PANAMA CANAL AUTHORITY		VARIATION	PAGE 1 OF 2
1. REQUEST FOR PROPOSAL No.:	2. CONTRACT No.:	3. DATE:	
RFP-76161	CMC-221427	April 18, 2012	
		4. VARIATION No.:	
		035

This Variation No. 35 is issued to extend the Contractor's operations to the following working area at the Pacific Site:

THIRD SET OF LOCKS PROJECT
PACIFIC LOCKS COMPLEX
TEMPORARY STOCKPILE
AT CARTAGENA
STOCKPILE CSN1
PLAN

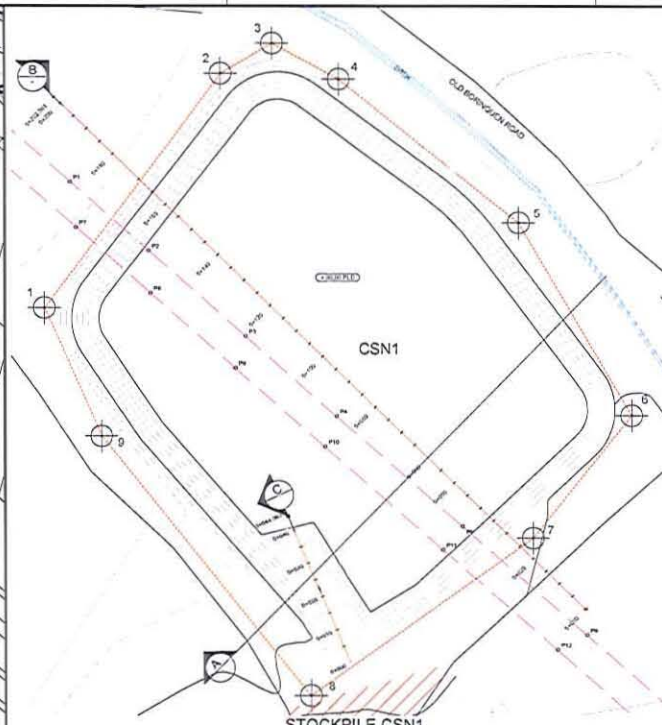
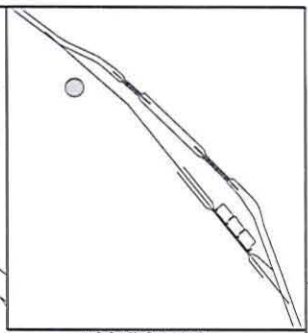
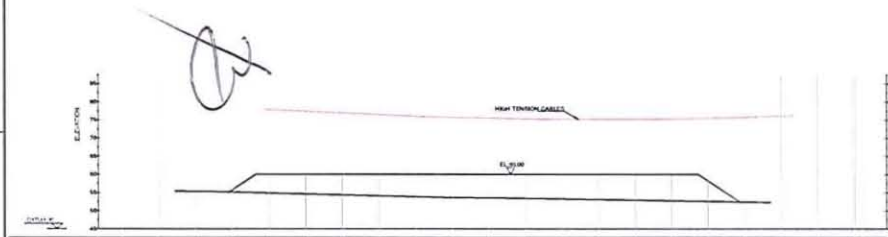
Designate the area shown in the attached Drawing 6127-P-A-B-3073 (Revision 1), delineated by coordinates 1 through 9, and associated access roads, as a temporary area for stockpiling basalt for future transportation to the Cartagena Loading Facility, subject to the Contractor's:

- Compliance with quality, safety and environmental requirements established in the relevant Sections of the Employer's Requirements.
- Submittal of an updated version of the Safe Work Plan "Transporting of Aggregate to Cartagena Dock" to incorporate the appropriate revisions and the risk analysis of the activities related to the use of stockpile area CSN1.

The CSN1 Area is defined by the following coordinates:

POINT	NORTH	EAST
1	997265.323	650783.006
2	997330.172	650831.174
3	997338.451	650845.293
4	997328.581	650863.399
5	997288.908	650912.496
6	997235.822	650943.323
7	997201.835	650916.303
8	997158.170	650855.601
9	997230.009	650798.629
